THE CITY OF WALTHAM
MASSACHUSETTS

Mount Feake Cemetery Expansion

ADDENDUM NO. 2

October 14, 2014

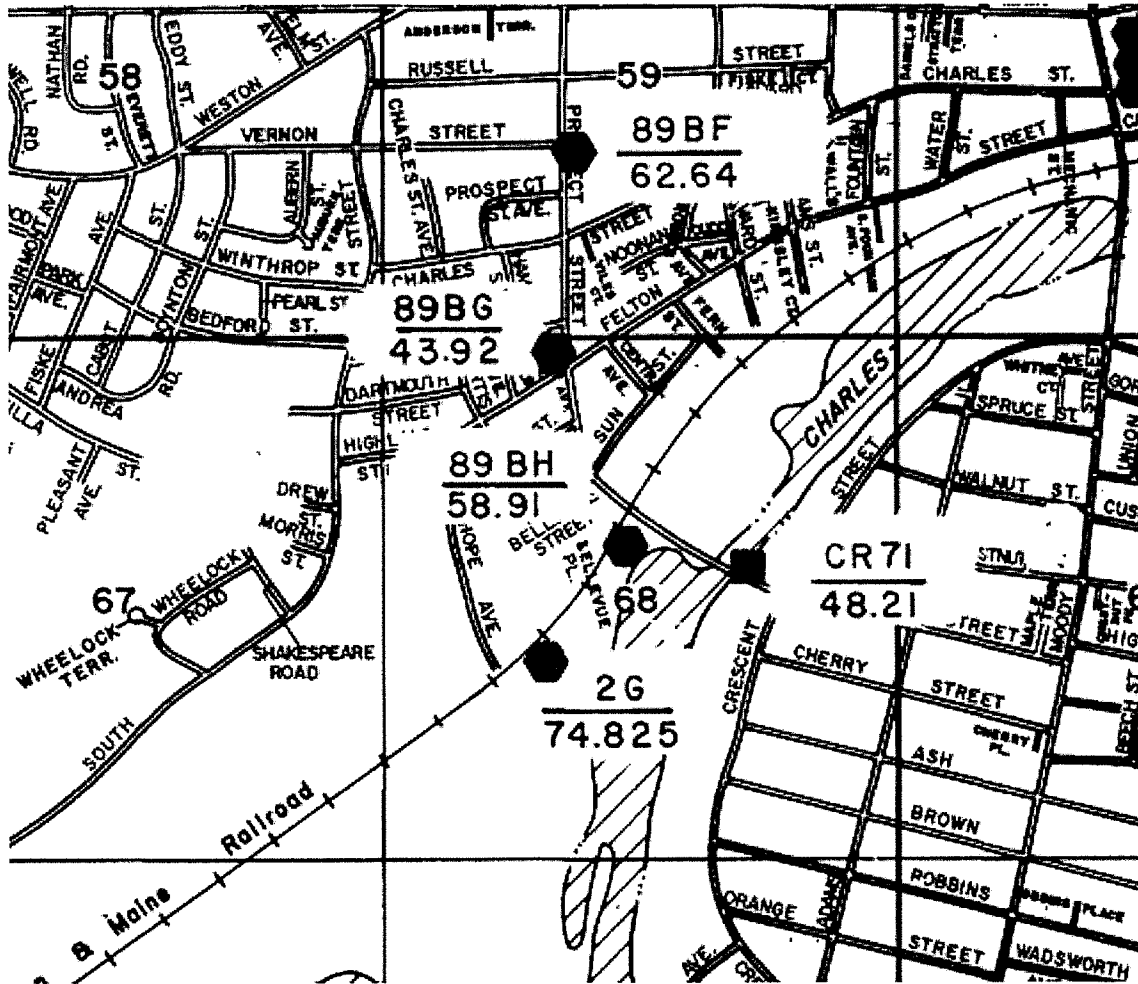
Q2. Would the new water supply be fed from a public water supply or another source such as a well? If the information is available, please indicate the pressure and gallons per minute of the water source.

A2. The new water supply line will be fed from the public water supply. New water lines should tie into the existing water system within the Cemetery.
